In respect of a permit application to operate a 'moving grate' incinerator in Westbury, Wiltshire
Environmental permit consultation mailed to: PSCpublicresponse@environment-agency.gov.uk

BA13 4WE, Northacre Renewable Energy Limited - EPR/CP3803LV/A001:

Northacre Facility - Northacre Industrial Estate - Northacre Facility Stephenson Road
Forbury Court - BA13 4WE – ***Directly adjacent to the town of Westbury (Population 18,000)***

Metrological data & atmospheric / temperature inversion

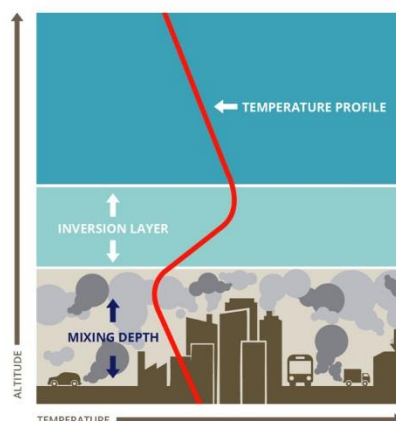
in relation to actual terrain / topography:

As already noted, the Air quality report is based on met data from Lyneham, about 20 miles away on the flat, whereas Westbury lies in the valley with steep escarpment up to Salisbury plain. (see header and foot images) This topography results in events of temperature inversion and plume grounding.

Straightforward numbers on the scale of HGV’s are Missing

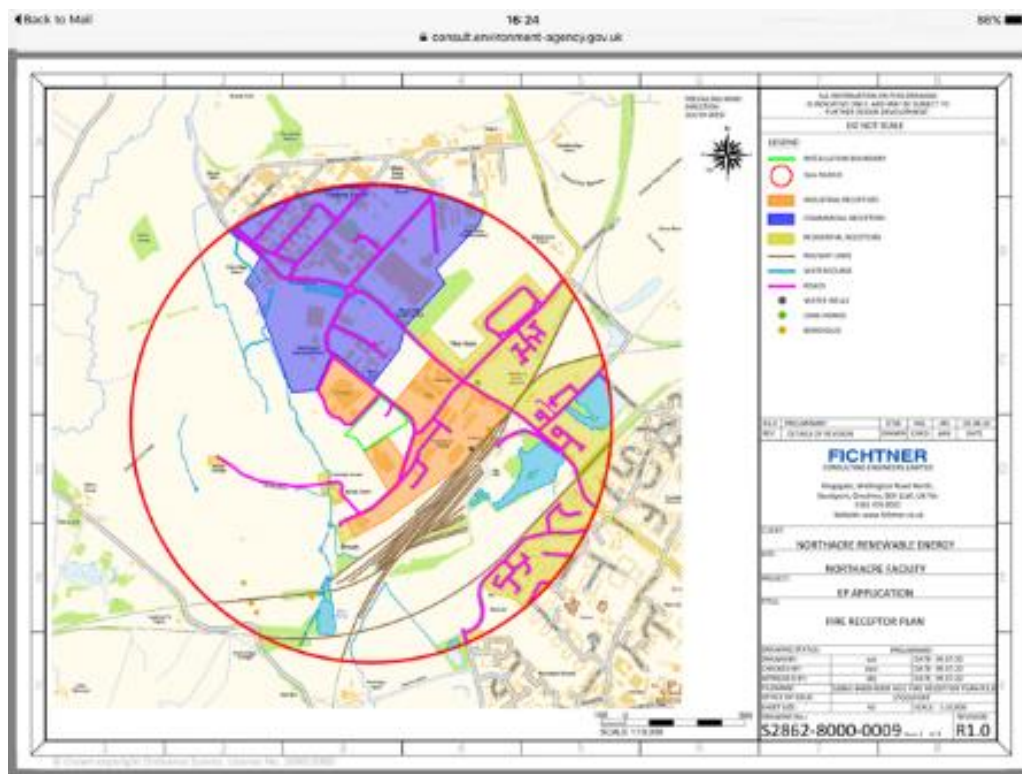
It would seem a simple request, but since Hills first applied to build an incinerator on 22 December
2014, the Company has been very reluctant to publish clear straight forward numbers of HGVs
involved in transporting materials for all subsequent incinerators, using instead complicated
comparisons which usually concluded that there would be no, or ‘hardly any’ changes in traffic
volume.

This left the residents trying to work it out by comparing with other incinerators with the same
technology but with more transparent information available. Why is that?

Will you tell us now, how many lorries it would take to bring in quarter of million tonnes of waste,
supplement fuel, other chemicals and take away large amounts of residues?
And if not, why not?
